F53 Wire Harness and Brake Cable Securement

Bulletin Type:	Safety Recall	Publication Date:	January 2022
Bulletin #(s):	21V-997 US 2021-781 Canada	Make(s):	Jayco Entegra Coach
Job Code(s):	9903573A-Inspect Only 9903573B-Inspect and Secure Harness	Model(s):	Alante Class A Vision Class A
Flat Rate(s):	9903573A - 0.1 Hr. 9903573B - 0.25 Hr.	Model Year(s):	2022

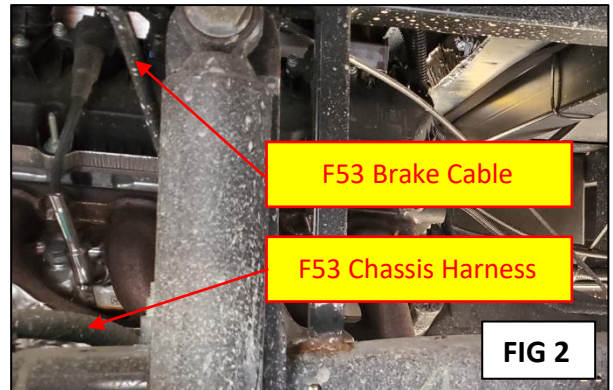
- Using the forward jacks, lift the front of the unit until front tire is slightly off the ground.
(Fig. 1)

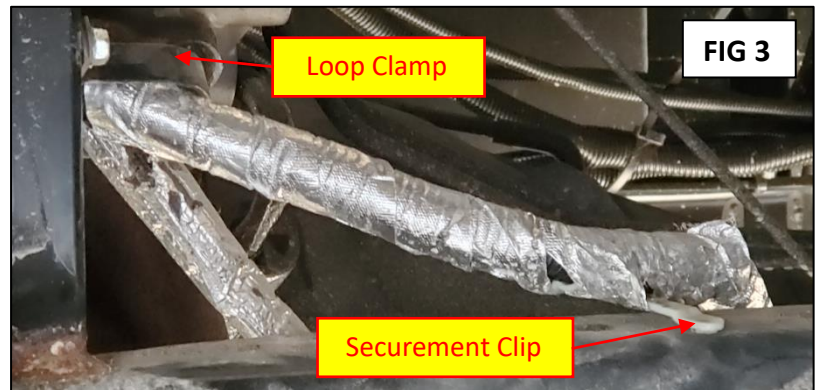
2. Locate chassis wire harness and brake cable which is not secured between the frame rail and engine. (Fig. 2)

3. Using loop clamp and TEK Screw, secure both the wire harness and brake cable to the vertical tube. (Fig. 3)
4. If the wire harness has the plastic securement clip, re-install in the top of the frame rail. (Fig. 3)
5. Raise the forward jacks.
